PCN-20230327 TE0745-02 to TE0745-03 Hardware Revision Change

Company	Trenz Electronic GmbH
PCN Number	PCN-20230327
Title	TE0745-02 to TE0745-03 Hardware Revision Change
Subject	Hardware Revision Change
Issue Date	2023-06-27

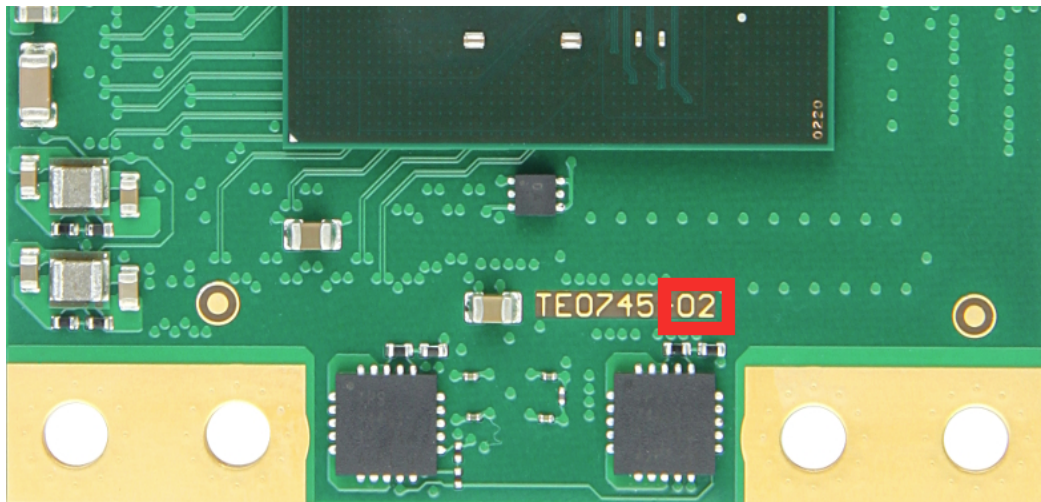
#33 Change PCB color from black to standard green.

Reason: Standardization.
